UNITED STATES PATENT AND TRADEMARK OFFICE

APPLICATION NO.	FILING DATE	FIRST NAMED INVENTOR	ATTORNEY DOCKET NO.	CONFIRMATION NO.
10/528,986	03/24/2005	Robert Simm	3210	6382
7590 Striker Striker & Stenby 103 East Neck Road Huntington, NY 11743			EXAMINER CADUGAN, ERICA E	
			ART UNIT 3722	PAPER NUMBER
SHORTENED STATUTORY PERIOD OF RESPONSE		MAIL DATE	DELIVERY MODE	
3 MONTHS		01/29/2007	PAPER

Office Action Summary

DETAILED ACTION

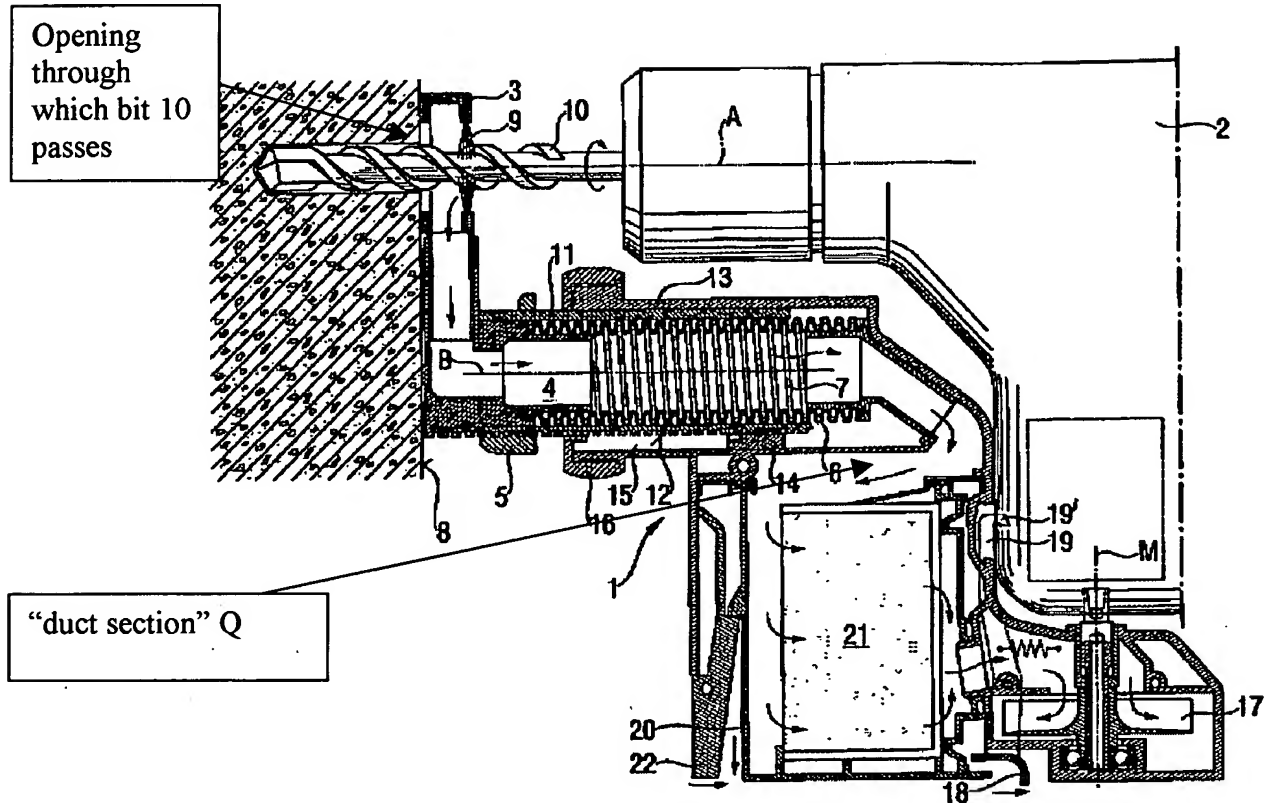
Re claims 4 and 6, note that the “suction head” 1 is supported on the housing of the power tool 2, and is detachably retained thereon via a snap-in connection 19, 19'. Re the claimed “unit” and “bearing unit” of claim 4, as broadly claimed, it is noted that a “unit” including a “bearing unit” including at least elements 13, 11, and 5 “support” the “suction head” 1 on the housing of the power tool 1 (insofar as the guide rods 46a and 48a forming the disclosed

Re claim 7, it is noted that the “suction head” 1 is supported on the housing of the power tool 2 by the “bearing unit” including at least elements 13, 11, and 5 as described previously. It is further noted that the suction head 1 is indeed, as broadly claimed, “displaceable along a working direction” (such as the left right direction of the A axis of Figure 1) by, at the very least, moving the entire device (i.e., the power tool 2 in combination with the suction head 1) in the left-right direction as viewed in Figure 1, at the very least to move the device into a position adjacent the workpiece.

Re claim 8, note that the aforescribed “bearing unit” including at least elements 13, 11, and 5 includes the depth stop 5 (see Figure 1 and paragraph 0024).

Re claim 9, note that the suction head 1 includes at least one opening (labeled below in the reproduction of Figure 1) through which the tool bit 10 is guided during a drilling operation of the workpiece (workpiece is at the left side of the Figure and has a surface 8).

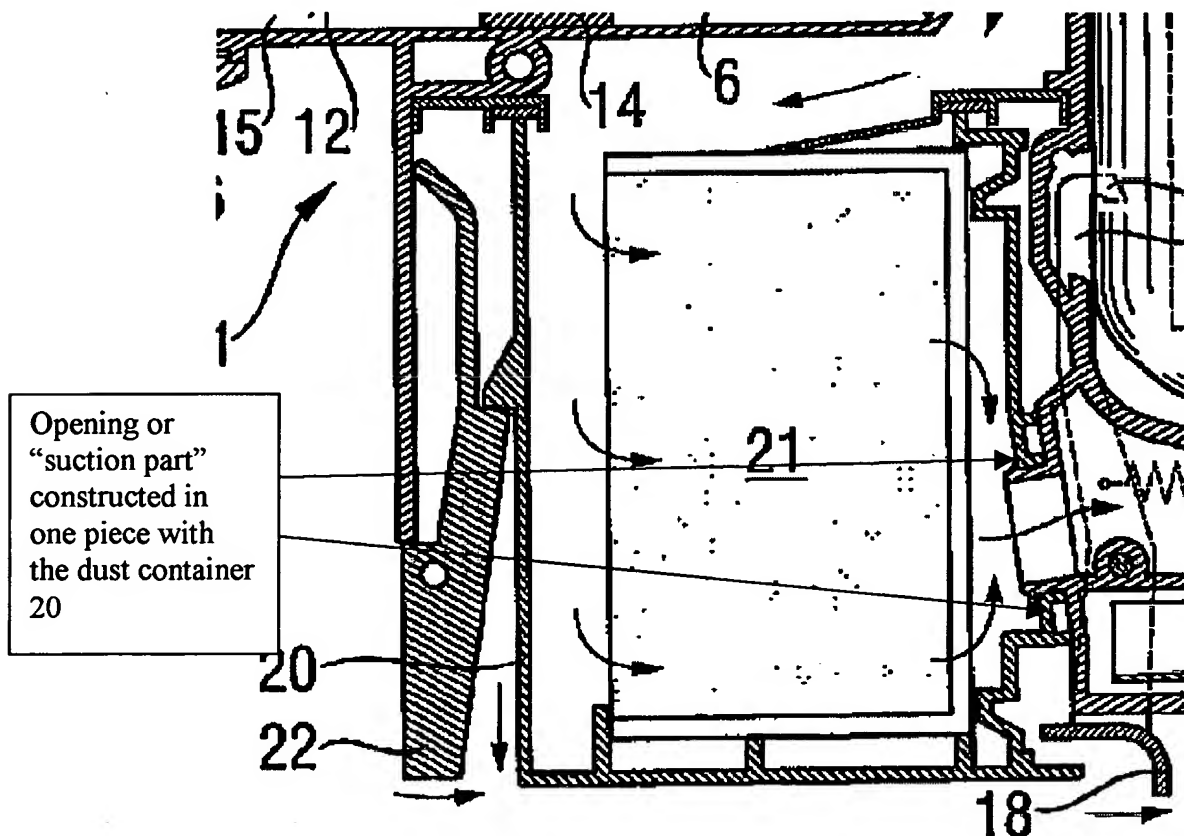
Re claim 12, an air stream (at least as defined by the arrows in Figure 1) is “capable” of being introduced into the dust container 20 through a “duct section” (including at least any one of the hollow portions 3 or the tube 4, or the above-labeled “duct section Q”, for example) in a circumferential direction of the dust container (see Figure 1).

Re claims 14-15, it is noted that the “suction part” 34a-34c of the present invention is not any sort of vacuum, but is merely a part through which suction occurs. That being said, it is noted that the above-labeled “duct section Q” is a part through which suction occurs, and which

is thus considered to be a "suction part", and which "forms a single unit" (claim 14) that "forms an indivisible unit" (as best understood, see Figure 1 noting that at least the lower side of the duct section Q is of the same piece as the container 20 (see Figure 1). [Alternately, note that the opening through which air passes as it leaves (on the right side) of the dust container is a part through which suction occurs, which could thus alternatively be considered the claimed "suction part", and which is a single unit that is indivisible with the "dust container" 20].

Re claim 16, considering the alternate interpretation of the "suction part" set forth in the immediately preceding sentence, see the enlarged and labeled portion of Figure 1 below.
